SUBJECT: 25-S2-10001-03140  
Eagles Express C-Store Renovation  
Due: 5-14-24 / 2PM / Local Time

#### Addendum #1

<b>Project:</b>	Eagle Express Convenience Store Renovation 7700 Mahrenholz Rd Evansville, IN 47712	<b>Addendum No.:</b>	001
		<b>Date:</b>	April 26, 2024
<b>Owner:</b>	University of Southern Indiana 8600 University Blvd Evansville, IN 47712	<b>Project Number:</b>	2312-357
		<b>Contract for:</b>	All Construction

Architect's Project No: 2312-357 Date: APRIL, 2024

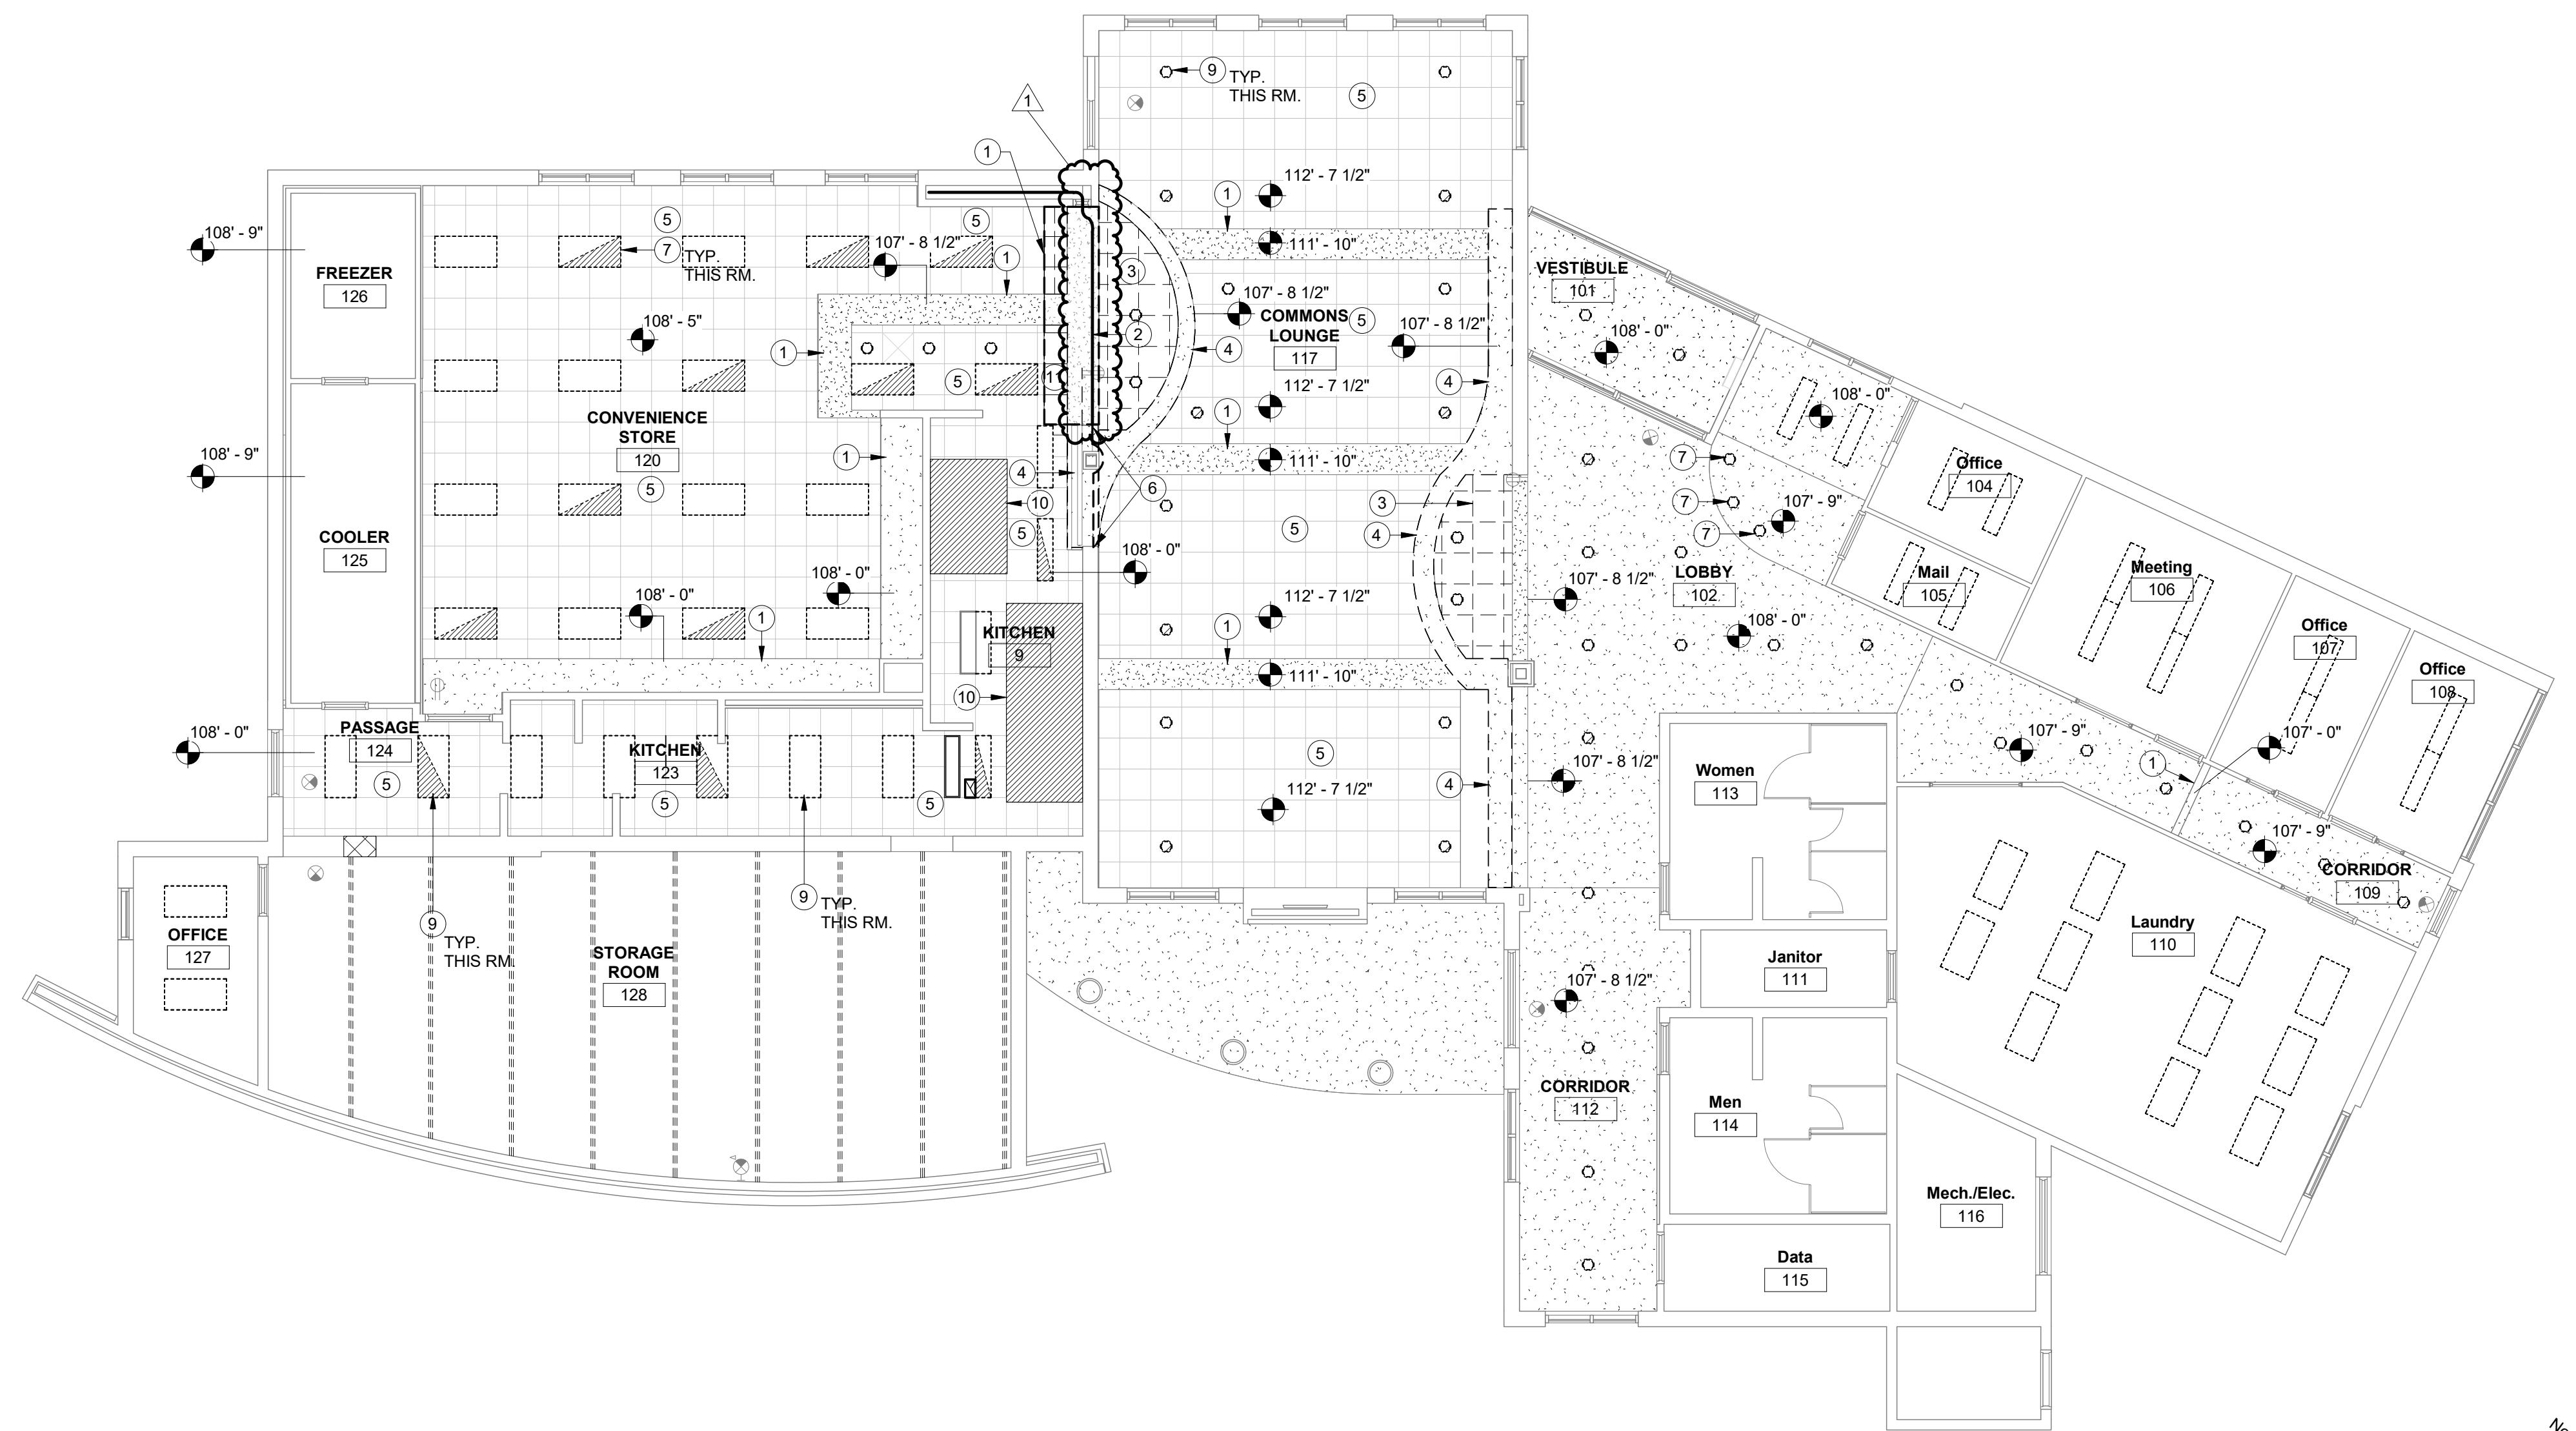
- 1-4 Drawing A1.1 Demolition Plan & Floor Plan:
  - A. This Drawing is being reissued to revise notes as shown.
- 1-5 Drawing A1.2 Reflected Ceiling Plan:
  - A. This Drawing is being reissued to revise notes as shown.
- 1-6 Drawing A1.3 Roof Plan & Details:
  - A. Details 3 & 6/A1.3 and Interior Elevation 8/A1.3 has been revised to better represent required conditions.
- 1-6 Drawing E3.1 Lighting Plan
  - A. This drawing is being reissued to revise missing fixture tags.
- 1-7 Drawing M2.1 HVAC Details and Schedules, Rooftop Unit Schedule
  - A. Revised model number for RTU-1.
  - B. Provide roof curb adaptor as required for all units.
